Recall Bulletin

PRODUCT SAFETY RECALL

SUBJECT: Replace Ignition Lock Cylinder and Ignition Key

MODELS: 2005-2010 Chevrolet Cobalt
2006-2011 Chevrolet HHR
2006-2010 Pontiac Solstice
2005-2006 Pontiac Pursuit (Canada Only)
2007-2010 Pontiac G5
2003-2007 Saturn Ion
2007-2010 Saturn Sky

Replacement Key Modification

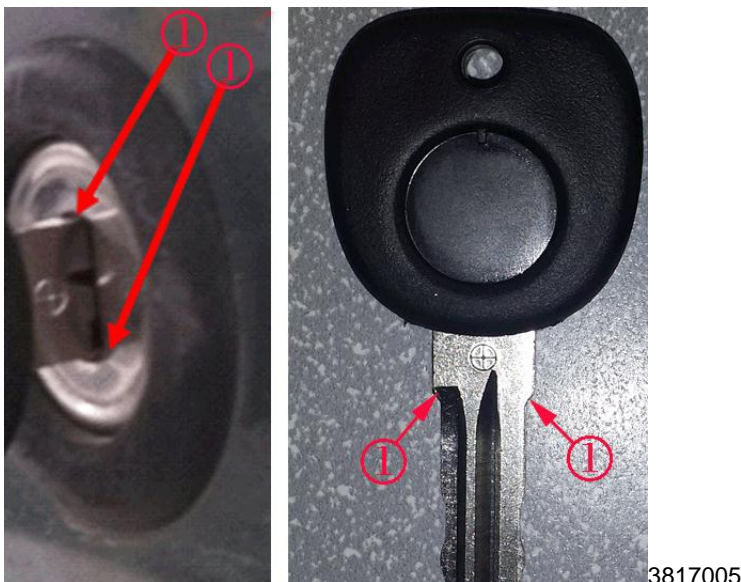
For the Saturn Ion only, if the replacement key profile is wider near the key head than the original equipment manufacturer (OEM) key, and it may only work in the ignition lock cylinder and not in the doors or trunk. The replacement key may require modification BEFORE it can be used to open a vehicle door or trunk. Perform the *Key Modification* procedure in this bulletin if the replacement key will not open the doors or trunk of the vehicle.

Note: Without the modification, the key stops on the shoulder and will not fully enter the key lock cylinder. Refer to the photograph.

1. Using a file, remove the extra width of key near the over molded head as shown in blue (1) in the photograph above. Removing this material makes the width of the key 8.3mm (same as the OEM key) rather than 10mm. This will allow the key to enter fully into the door and trunk lock cylinders.

2. Verify key function in the ignition cylinder as well as all door and trunk lock cylinders prior to delivery to the customer.
